PG&E Letter DCL-03-047

Docket No. 50-275, OL-DPR-80
Docket No. 50-323, OL-DPR-82
Diablo Canyon Units 1 and 2
Response to NRC Request for Additional Information Regarding License
Amendment Request 02-03, "Spent Fuel Cask Handling"

**PG&E Response to NRC Request for Additional Information Regarding License
Amendment Request 02-03, "Spent Fuel Cask Handling"**

Figure 1-1-1
Spent Fuel Cask Handling Route
(excerpted from DCPD FSAR Update, Figure 9.1-7)

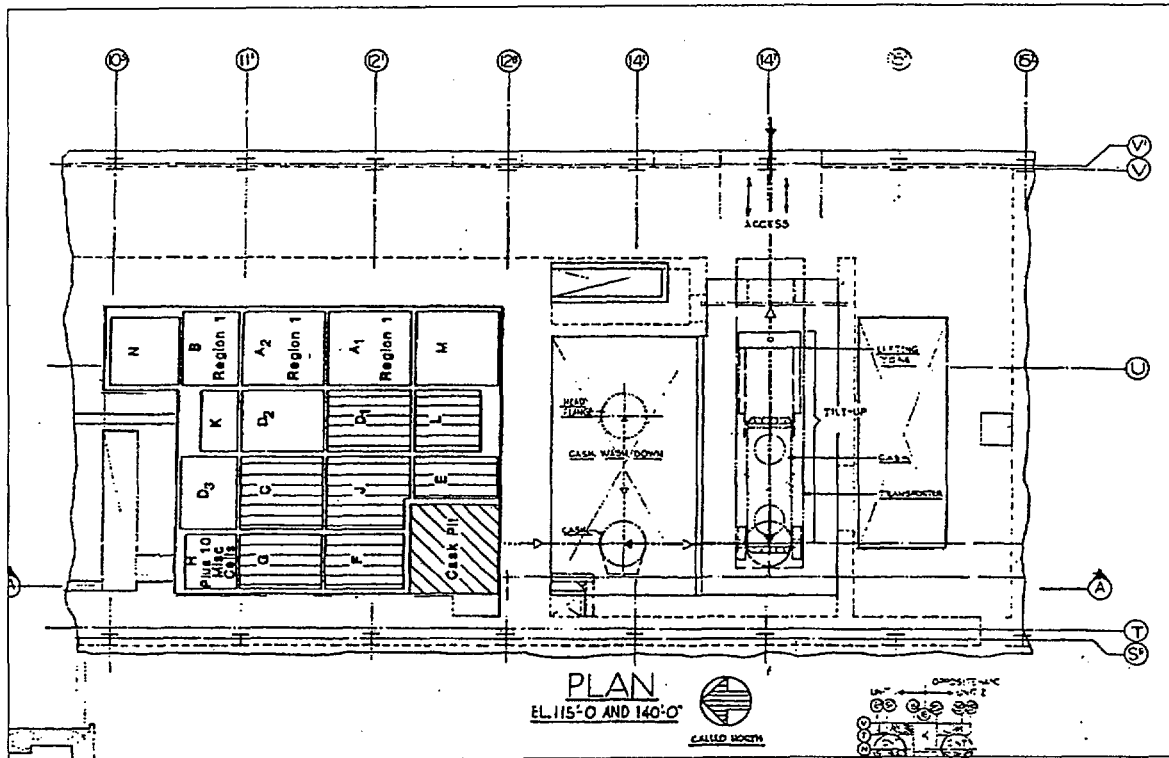
The proposed LAR requires revisions to plant procedures covering the handling of heavy loads. What procedures need to be revised and updated to implement the transfer cask/MPC operation? What training if any will be conducted to ensure personnel understand the new procedures and when will the training be completed? Additionally, if any other procedures require revision what procedures will be revised and what training will be conducted and when?

There are two commonly discussed "exclusion" areas or zones in the SFP area of the FHB/AB. The exclusion zone to be eliminated, is associated with the requirement to verify there is no spent fuel within storage rack regions depicted in FSAR Update, Figure 9.1-6 as "spent fuel cask exclusion zones," before a spent fuel cask can be moved north beyond Column line 12⁹ or South beyond column line 23¹. This requirement was in DCCP Technical Specification 3.9.13 until it was relocated to FSAR Update, Section 9.1.2.3.1 as part of License Amendments 135/135. Figure 1-1-1 depicts the Unit 1 configuration of the zone as excerpted from the FSAR Update figure. Note the striped storage rack modules adjacent to the cask recess area ("cask pit"). This zone restriction is currently implemented by a specific provision under FHB crane operating restrictions in IDAP MA1.ID14. Figure 1-1-2 depicts the Unit 1 configuration of the area as excerpted from the FSAR Update figure. Note that the cask is excluded north beyond Column line 12⁹ when fuel is present in the zone. Upon approval of this LAR, the restriction will be removed and nuclear fuel may be present in these storage

Figure 1-1-2
(excerpted from DCCP FSAR Update Figure 9.1-3)

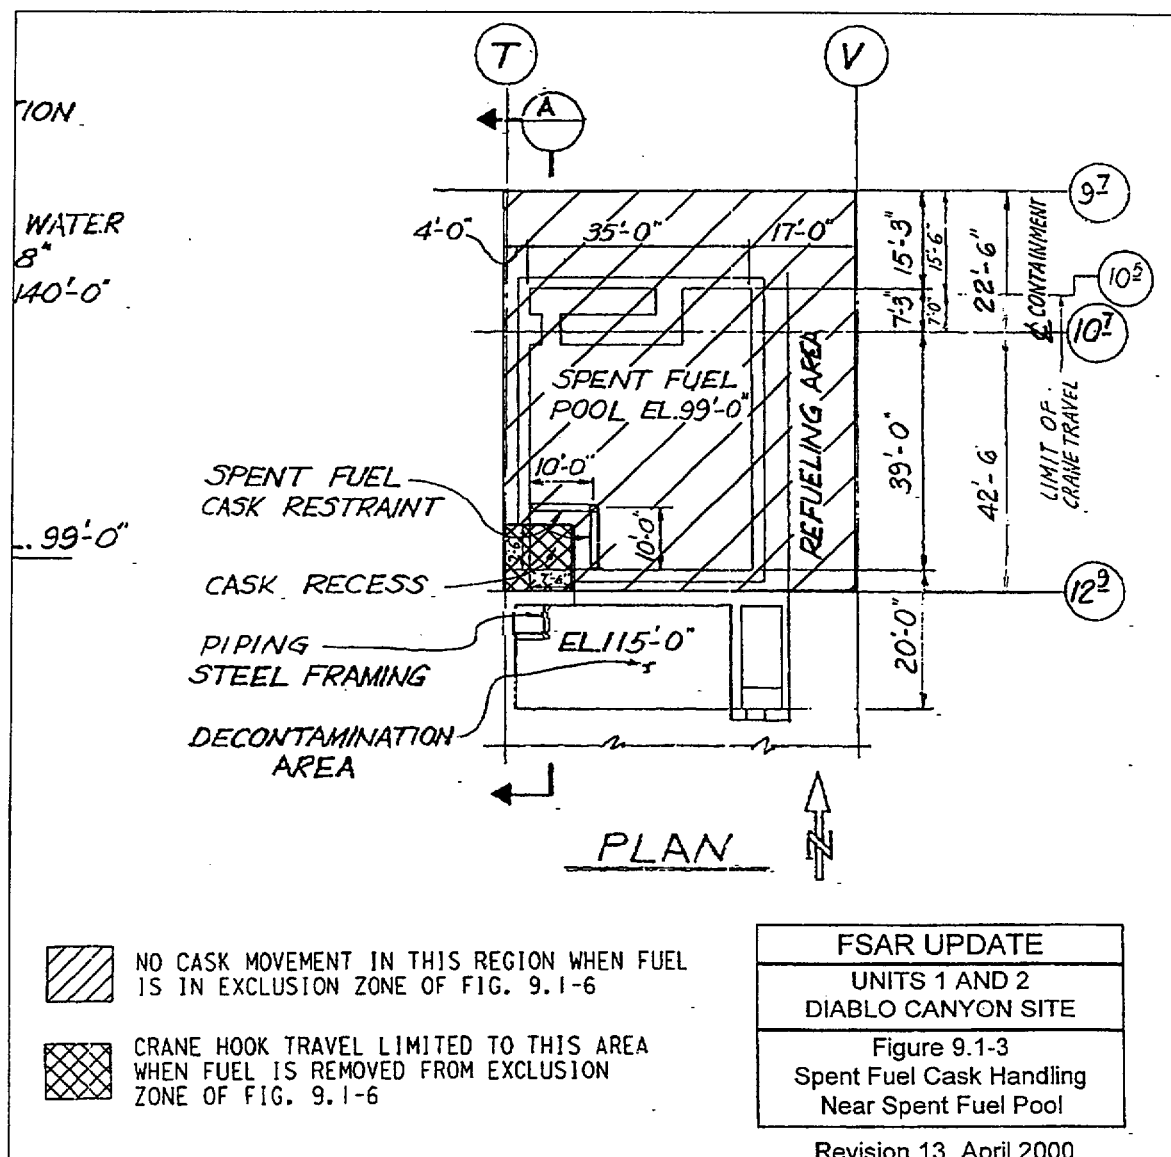
The Diablo Canyon Power Plant (DCPP) license amendment request to revise the DCPD updated final safety analysis report (UFSAR) regarding its control of heavy loads program proposes to eliminate the spent fuel cask exclusion zone. The UFSAR restricts cask movement to the portion of the spent fuel pool which is over the cask recess area. The defense-in-depth approach within NUREG-0612, "Control of Heavy Loads at Nuclear Power Plants," states that despite the increase reliability of the overhead handling system licensees should (1) provide sufficient operator training, handling system design, load handling instructions, and equipment inspection to assure

For clarification, PG&E does not intend to handle a spent fuel cask over any area of the SFPs other than the cask recess area as depicted in DCPD FSAR Update, Figure 9.1-3. The DCPD Control of Heavy Loads Program prohibits movement of all heavy loads over the SFP fuel storage racks unless specifically authorized by written procedures reviewed and approved by the PSRC. This program requirement is implemented in plant administrative controls by a "Heavy Load Exclusion Area". PG&E will not move the cask over the spent fuel storage racks, and the exclusion area over the fuel will not be eliminated.

Figure 1-4-1
Extension Link

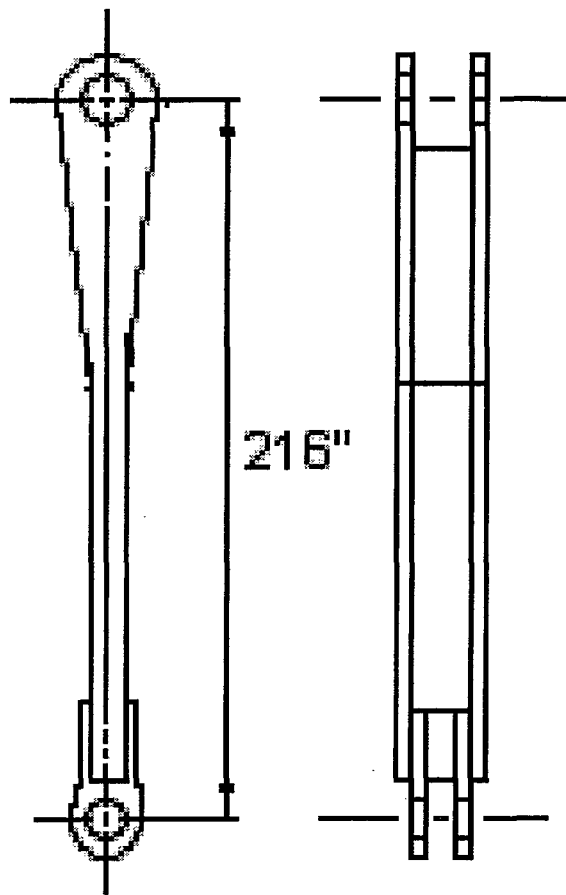
The auxiliary lift provides the overhead handling system with redundancy when used in heavy load handling operations. However, the submittal does not describe the design, testing, or inspection criteria for the auxiliary lift. Provide the design, testing, and inspection criteria applicable to the auxiliary lift and a description of the proof testing to completed at the manufacturers facility on the auxiliary lift to verify its ability to perform its intended function prior to the checking and testing performed at the place of installation.

The rigging between the auxiliary lift and transfer cask lift yoke is designed in accordance with applicable provisions of ASME B30.9 for the slings and ANSI N14.6 for the steel extension links (see Figure 1-4-1) used only for handling between the CWA and RSA locations. The rigid extension links (approx. 1,800 lb. ea.) are used in series with each sling from the auxiliary lift lifting beam to allow the sling to control the vertical displacement of the load during load transfer. Since the rigging to the cask lifting yoke is not redundant, a 10-to-1 factor of safety was used to select the slings per NUREG-0612 guidance, and the extension links are designed as special lifting devices per ANSI N14.6.

Figure 1-5-1
Fuel Handling Crane Load Paths

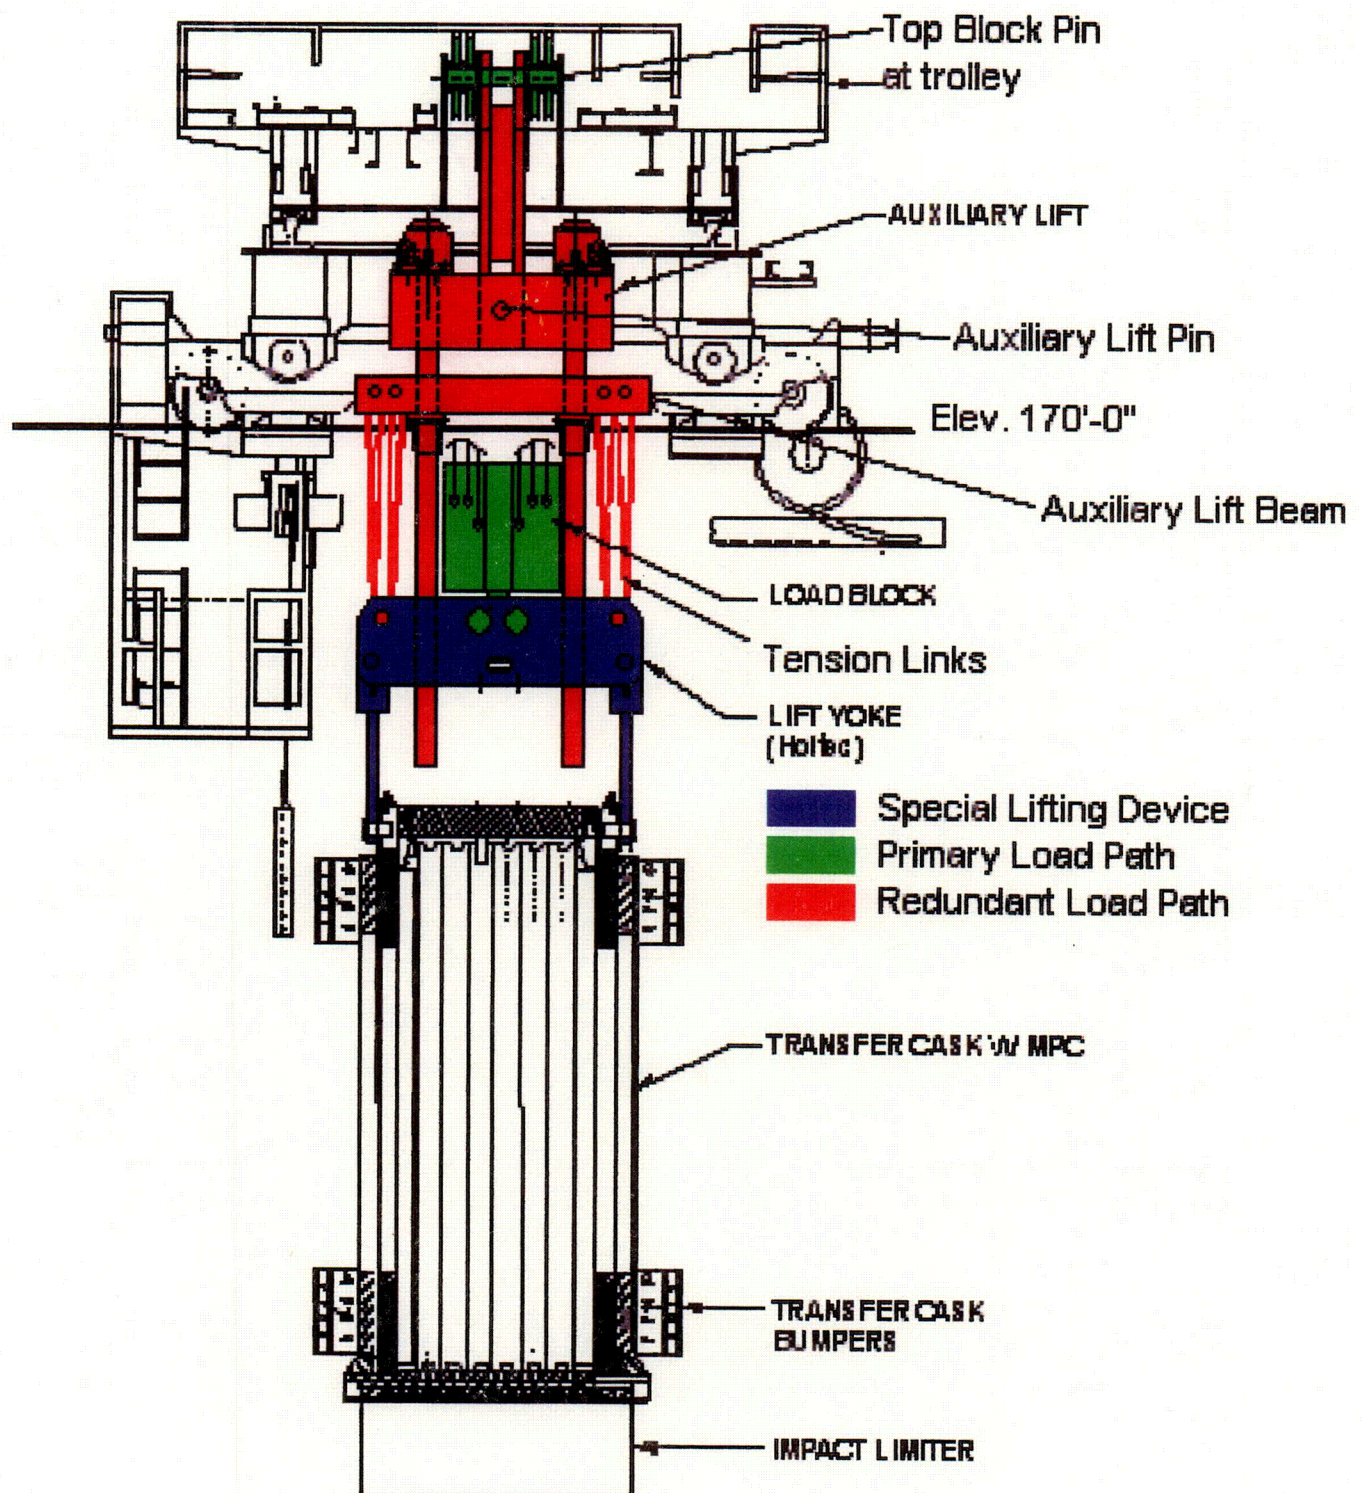
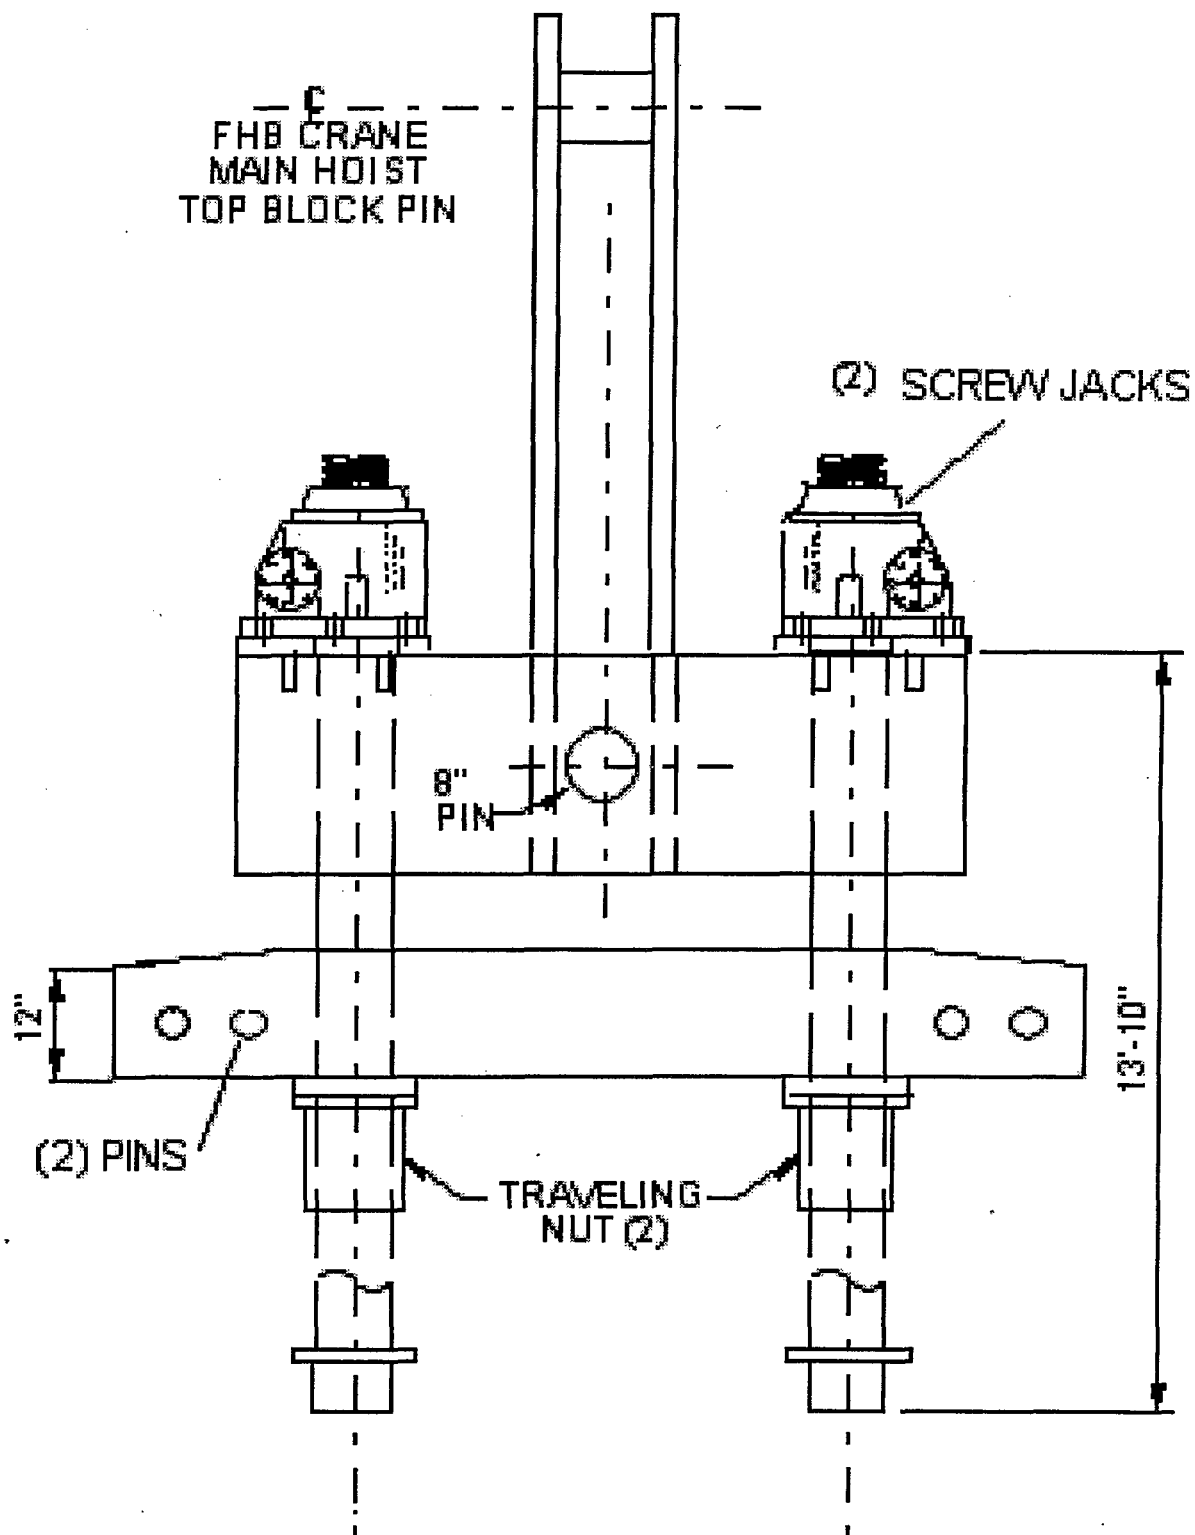
Although the original crane design was described in the December 5, 1984, NUREG-0612 submittal, describe how the auxiliary lift is design to move in the horizontal and vertical direction with respect to the crane bridge and trolley?

The auxiliary lift is an integral part of the crane trolley and moves horizontally with the crane trolley. Thus, east-west horizontal movement is accomplished by trolley movement along the girders of the FHB crane. North-south horizontal movement is accomplished by bridge movement along the FHB structure runway. Vertical movement of auxiliary lift lifting beam (approximately 96 inches) is provided by the rotation of the screw jacks. Coordination of the main hoist and auxiliary lift vertical movement is further described in response to NRC Question 1-6. During cask handling operations, the upgraded control system design of the FHB crane will be capable of prohibiting simultaneous, multi-axis load movement. One exception is the upending/downending operation of the transfer cask in the RSA on the cask transport frame where simultaneous trolley and main hoist operation is necessary.

The auxiliary lift is structurally attached to the trolley using the main hoist top block pin that also supports the main hoist sheaves.

See enclosed sketches of the trolley and auxiliary lift (Figures 1-5-1 and 1-5-2).
